29A Howitt Road
London, NW3 4LT

Basement Impact Assessment
Audit

Project Number: 12336-48
Revision: F1

September 2016

| Drawing Title Existing & Proposed Plans and Elevations | | | |

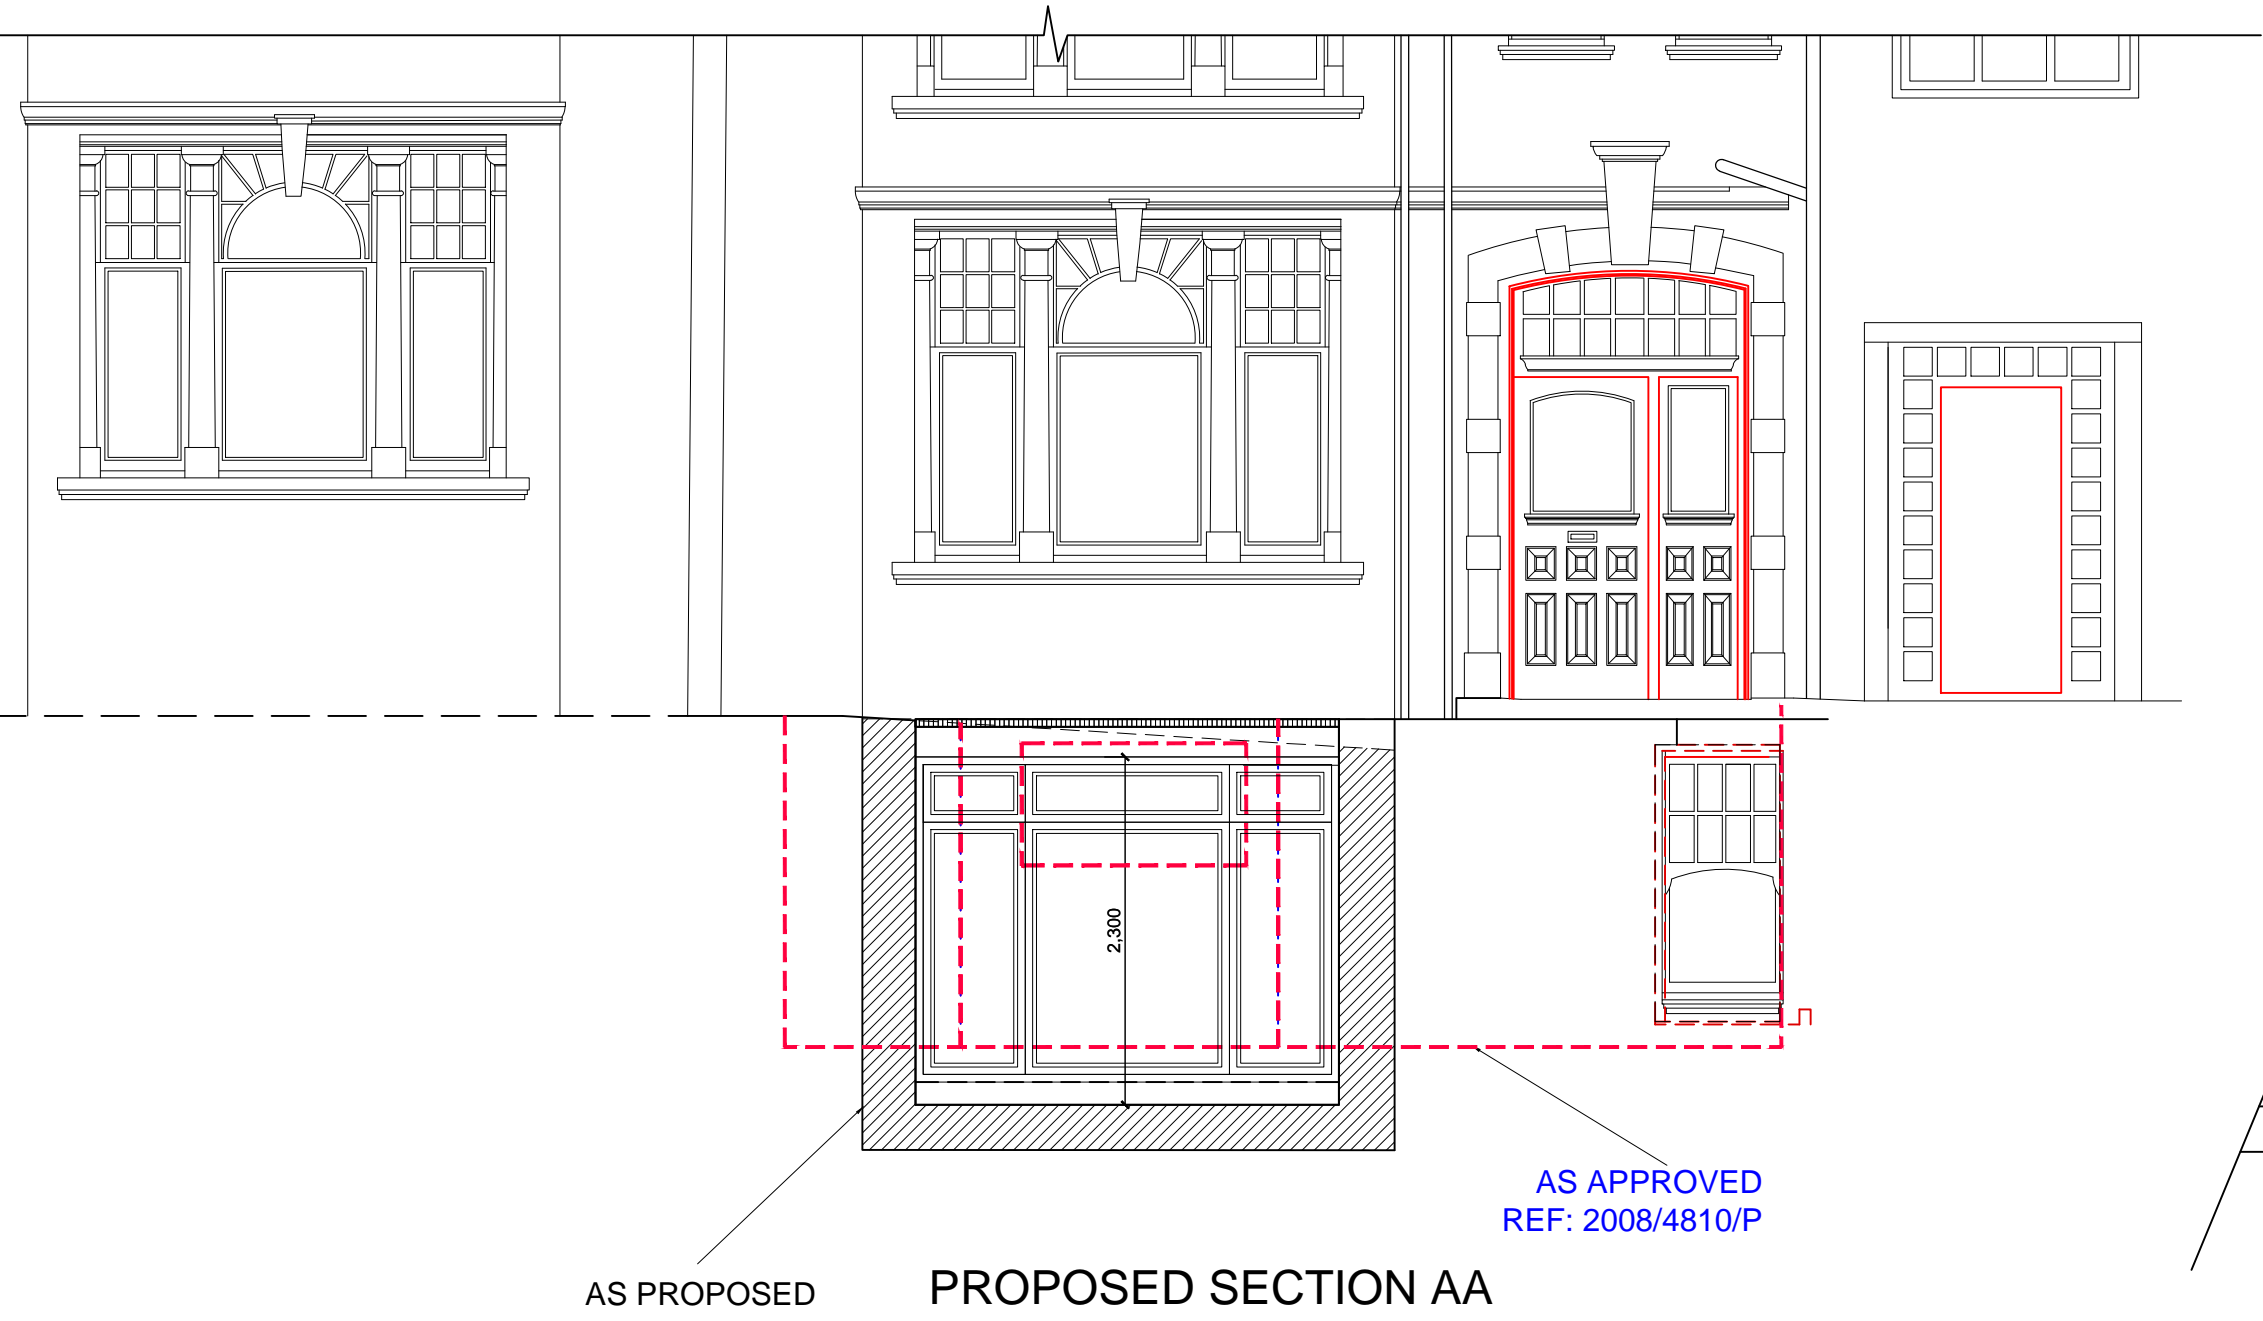
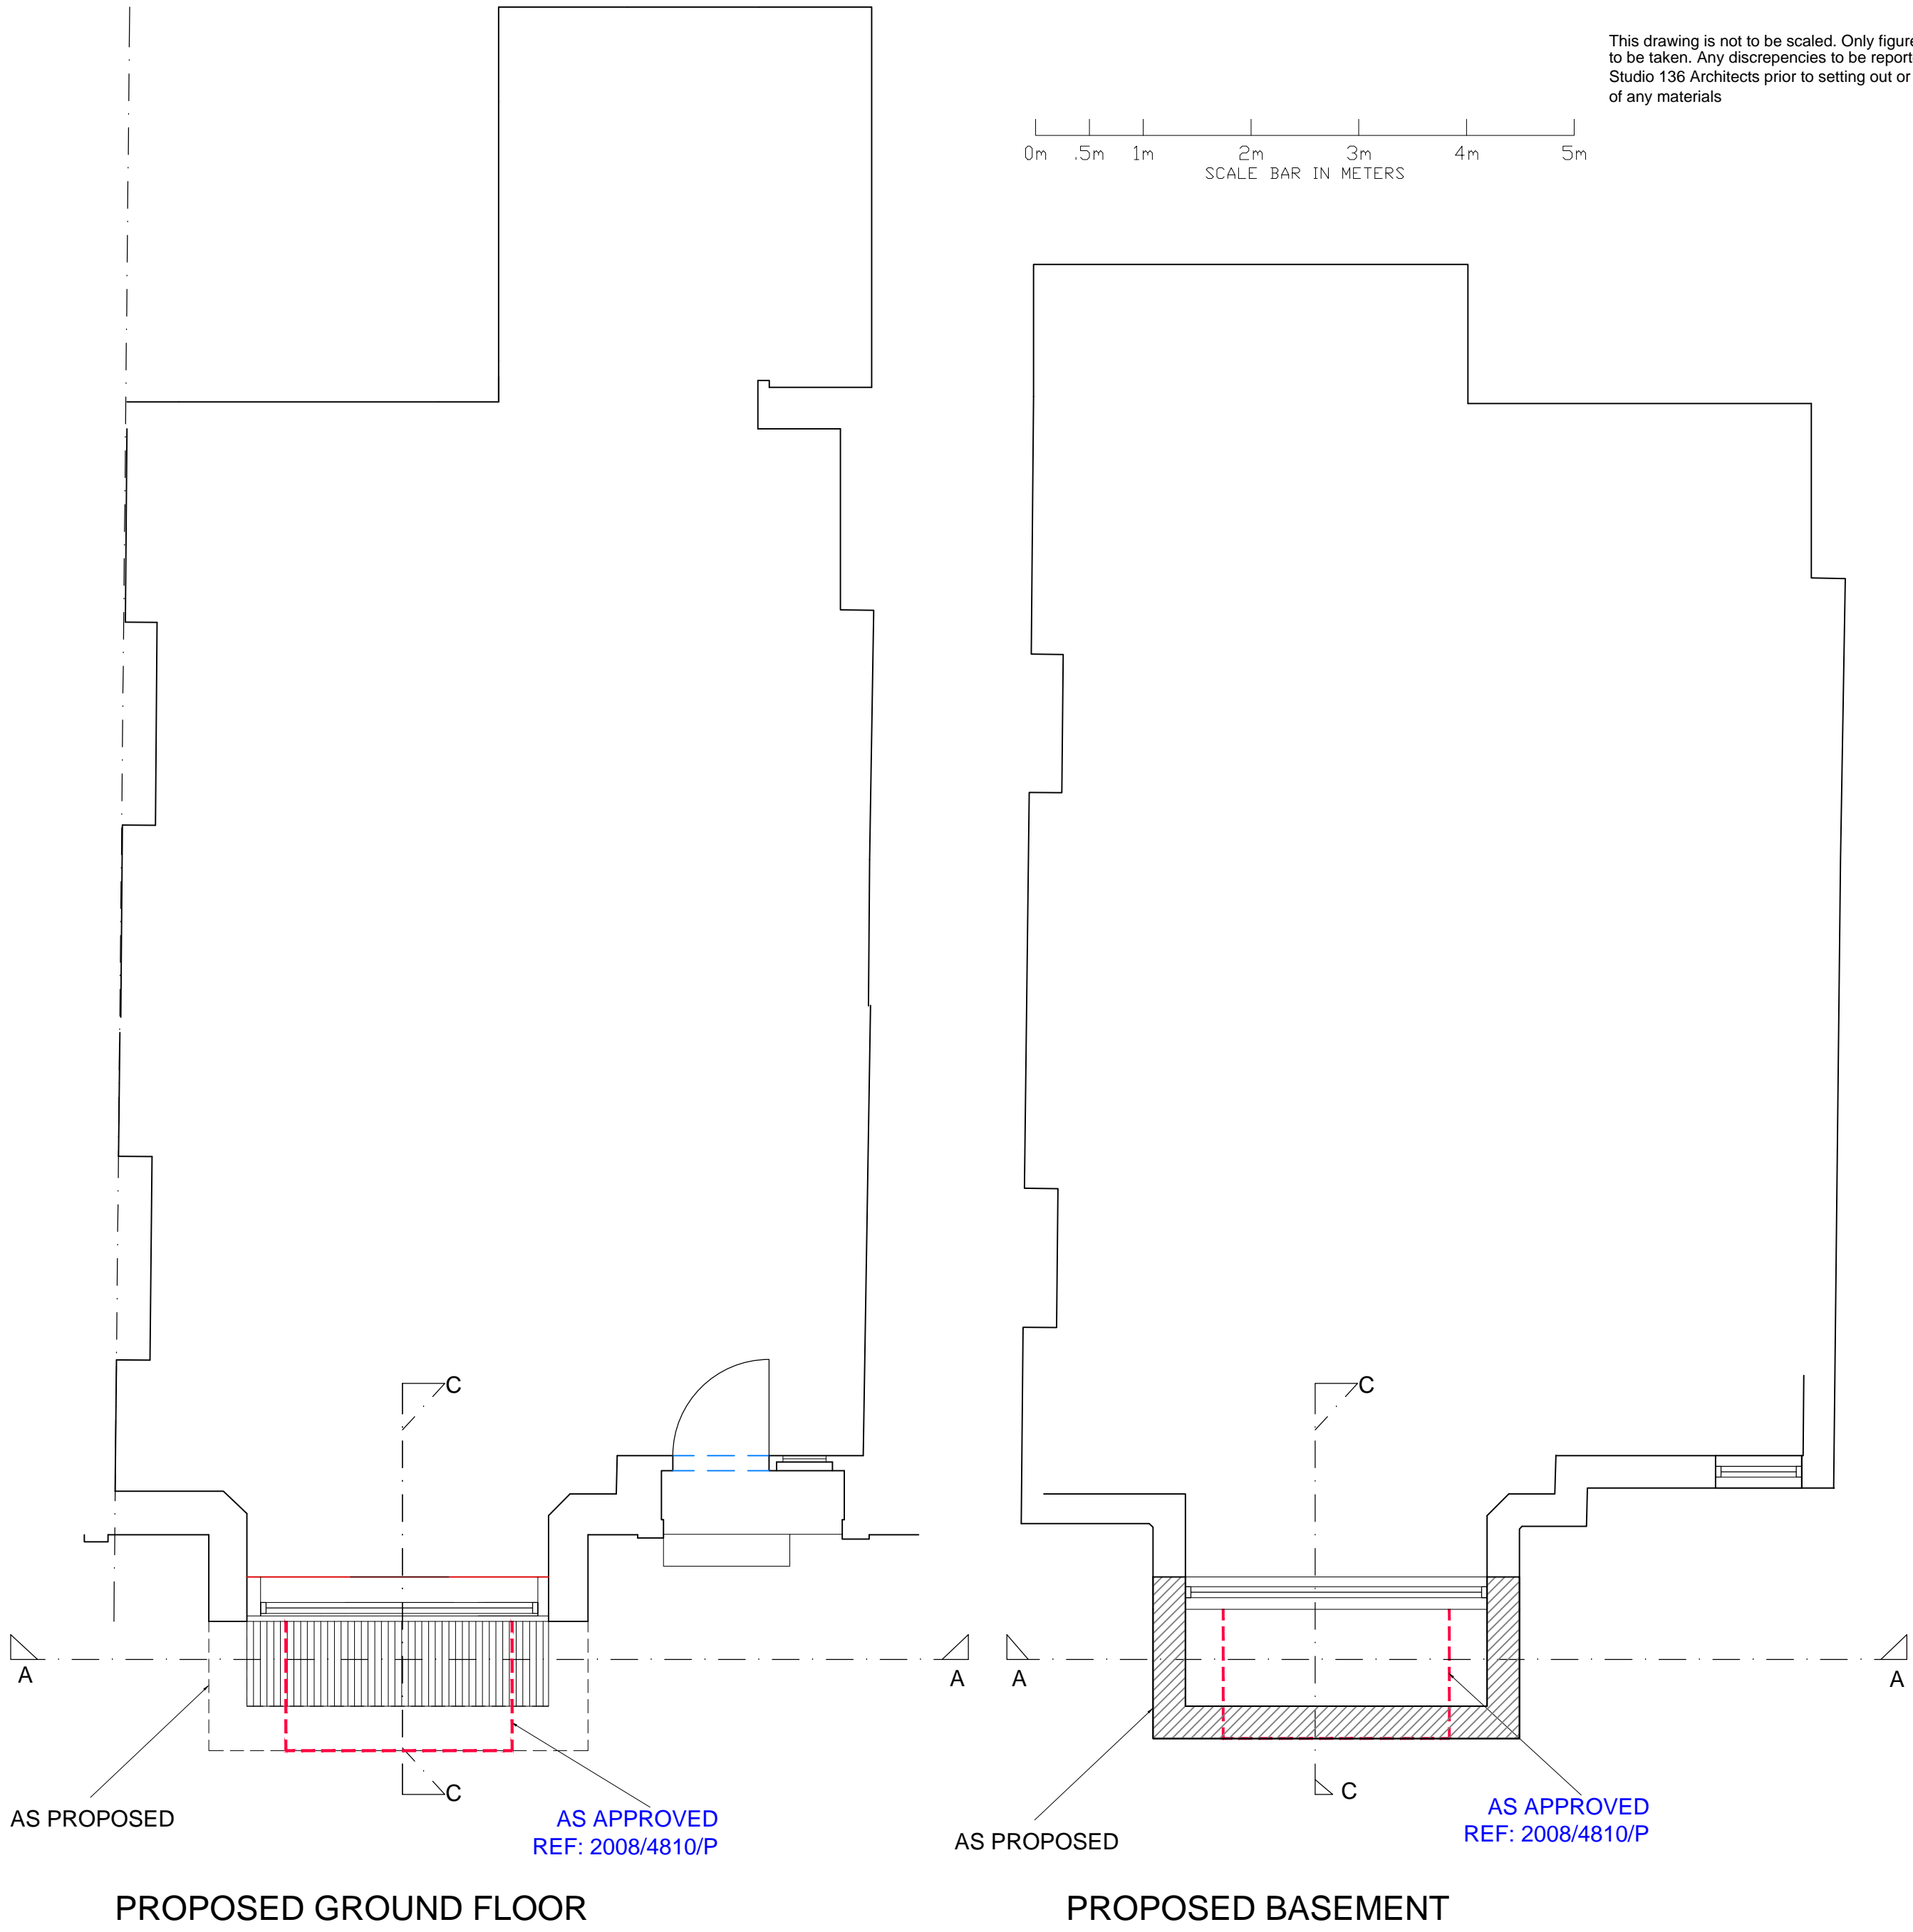
- 4.9. It was stated in the BIA that *'the basement is to be formed of a series of 1.20m wide underpins that are joined together to form a reinforced concrete box'* with no further details provided. A single drawing was provided to indicate the proposals. Structural Drawings by S R Brunswick Ltd were referenced on Section 1.4 of the BIA, however, these were not presented.

For the Architectural drawings proposed sections are included however it would be helpful if you've got existing sections. Not addressed but no further info requested.

Basement Plan

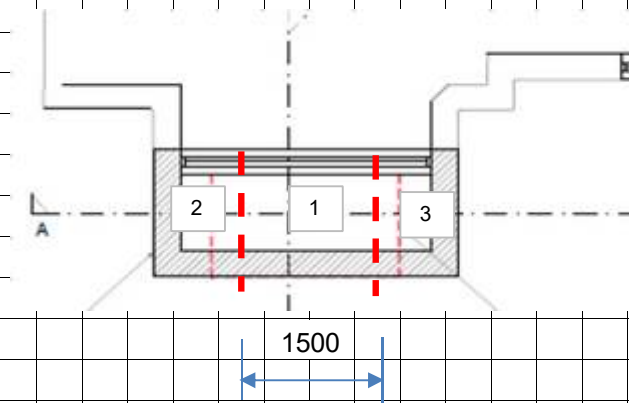
- 4.12. It was noted that the calculations provided in the BIA to justify the RC wall stability differed from the section drawing. It was requested that the methodology be amended to that shown in the calculations to maintain stability. Further clarification on how the lightwell would be built was subsequently provided on the temporary works drawing.

1) The further information confirms the lightwell walls will be formed in sequential sections with the central section formed first, followed by the two side wings. CPG4 guidance notes that "it must be demonstrated that the stability of existing buildings and the adjacent highway will be maintained at all times". It remains unclear from the information given how these sections of retaining wall will be formed without causing instability to the highway

and the adjoining property's bay windows. It is anticipated that some form of temporary retention would be required. An illustration, ideally containing a plan and section, illustrating the method of construction should be provided.

The calculations in the BIA indicate that in the permanent case the side returns of the new lightwell structure will be subject to broadly balanced loading. The central section will be subject to load from the highway side only and the calculations provided indicate that to justify the cantilever RC wall stability, a back span leg of 3m is required. The calculations differ to the section drawing provided. It is requested that the new retaining wall base will be formed to the geometry shown in the calculations such that stability is maintained as required.

I have added a section on the temporary works to show how this will be built and providing a slab of the required dimension by extending into the property and tying into the basement slab. This will inevitably happen as we don't want a joint at this point. SRB

Sequence of construction

The lightwell is to be constructed in 3 sections including the base utilising bent up bars at the construction joints which are to be provided water bars. The middle section (1) is to be constructed first with the base and on completion the concrete wall is to be propped allowing pins 2 and 3 to be excavated and concreted, these two sections can be undertaken at the same time.
